SUBJECT: SAN ONOFRE UNIT 2 100 PERCENT POWER LICENSE PACKAGE

Enclosed are copies of the Commissioner's Briefing package for the San Onofre Nuclear Generating Station, Unit 2, consisting of the vu-graphs, the operating license issued on February 16, 1982, and proposed license Amendment No. 5 authorizing full power operation. Also enclosed are previously issued Amendments 1 - 4 to the license.

1. Vu-graphs
2. Operating license limited to 5%
3. Amendments 1 - 4
4. Proposed Amendment 5

Figure 6.2-2 Unit Organization, San Onofre Nuclear Generating Station-Unit 2

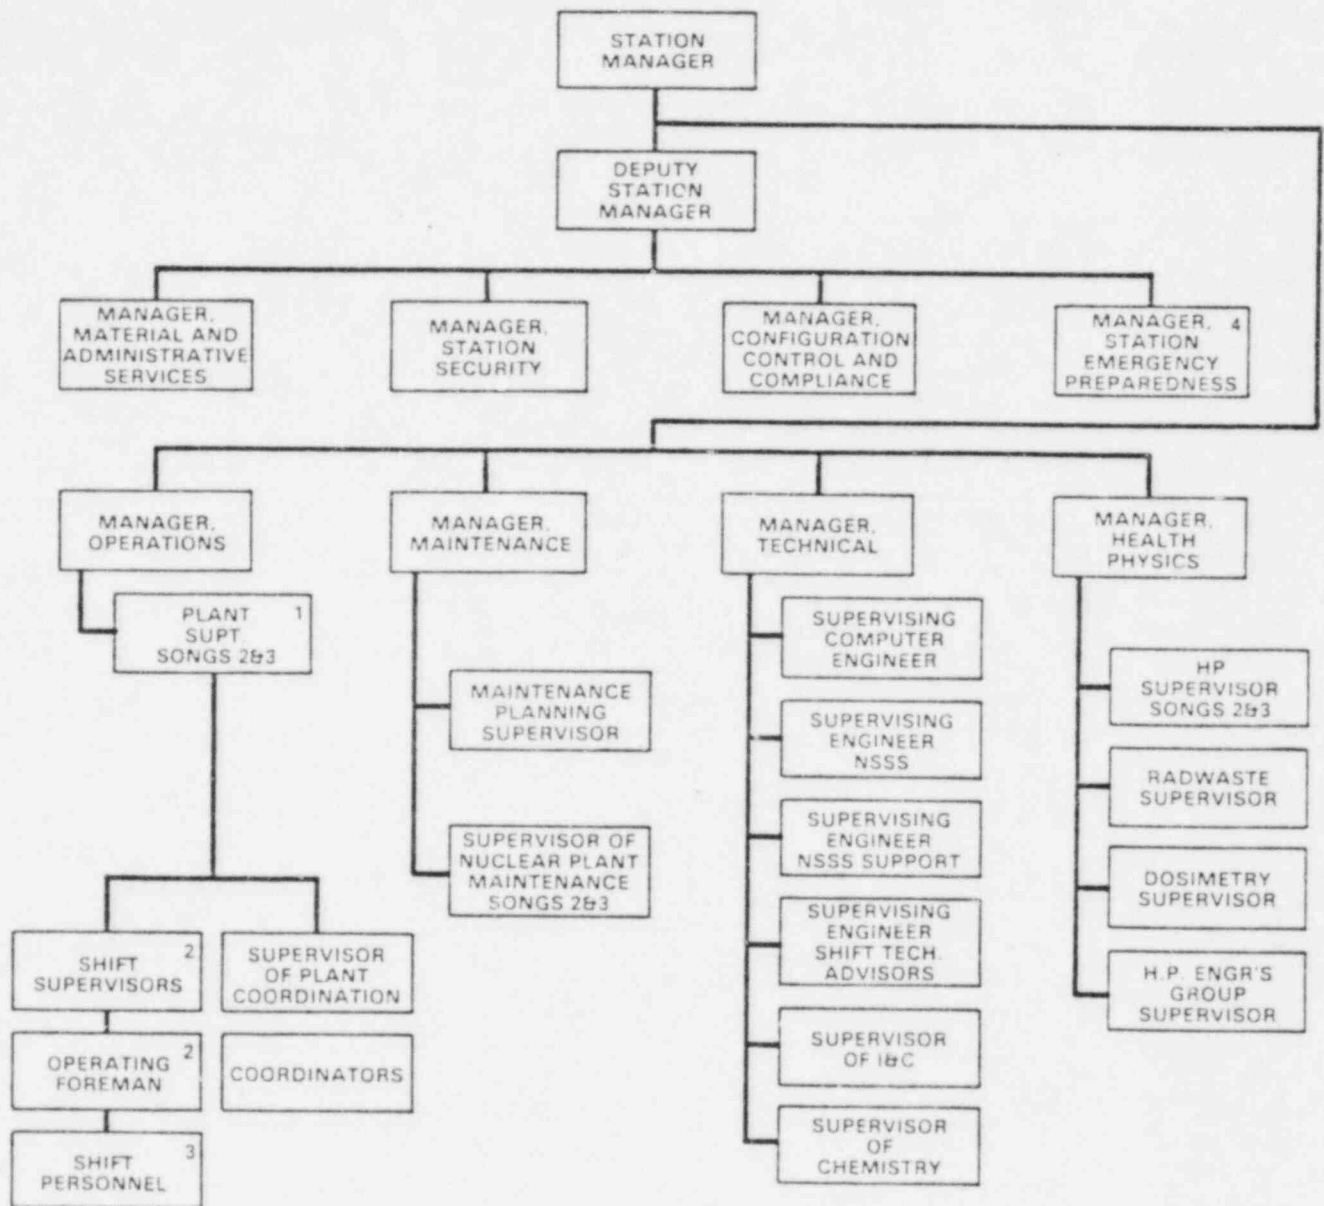
Change Technical Specification S 6.1-2, 6.2-2, Table 6.2-1, Figure 6.2-2 and Figure 6.2-3 to reflect current personnel titles.

The proposed changes to Figure 6.2-2 are primarily changes in position titles, as is suggested by the Licensee's description of the change. The inclusion of note 4 merely clarifies the fact that the Manager, Station Emergency Preparedness, is responsible for plant fire protection. There is no safety significance in these changes or in the deletion of the administrative position of Supervisor, Planning and Budgeting, under the Deputy Station Manager. Therefore, these changes are acceptable.

figure 6.2-3

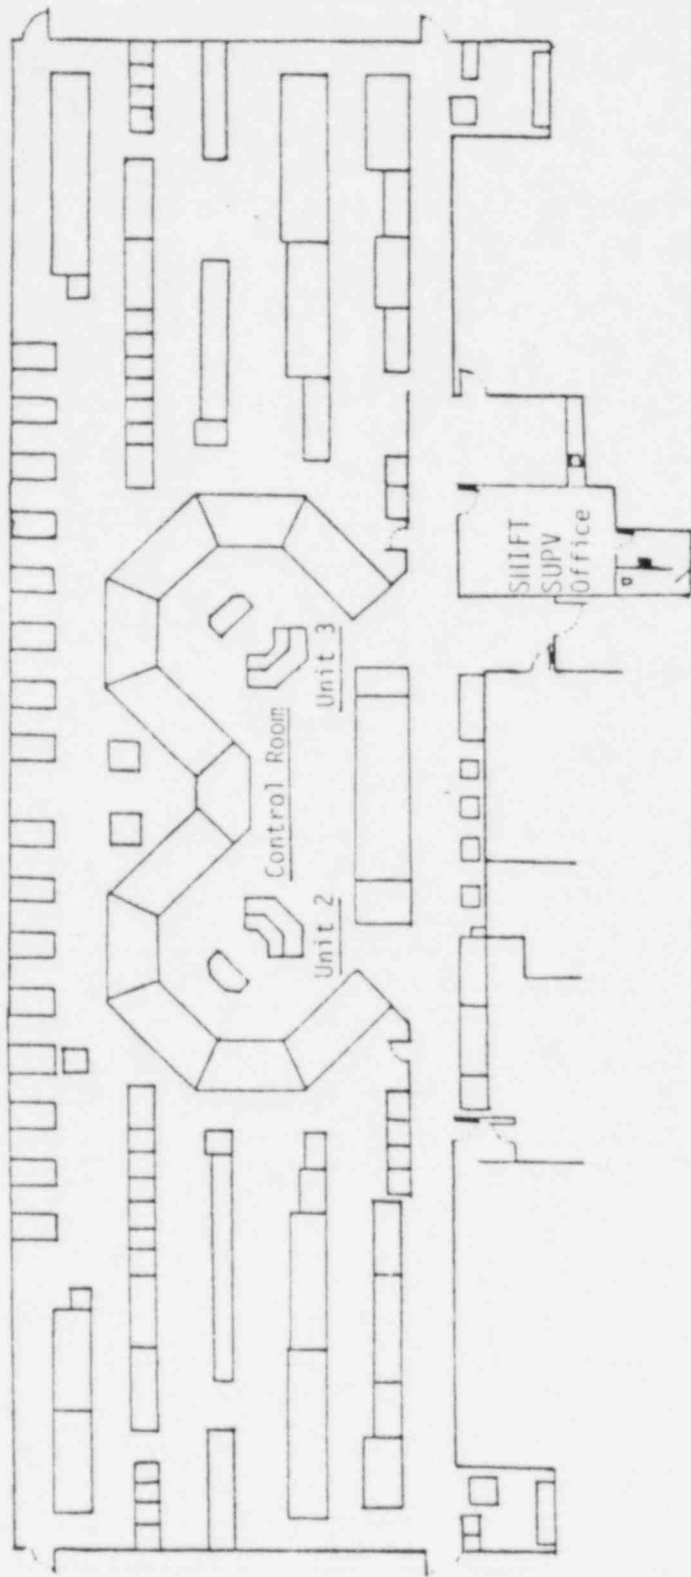
The proposed changes to Technical Specifications 6.1.2, 6.2.2.e, Table 6.2.-1 and Figure 6.2-3 are of no safety significance and are acceptable because they only change the "Watch Engineer" position title to "Shift Supervisor."
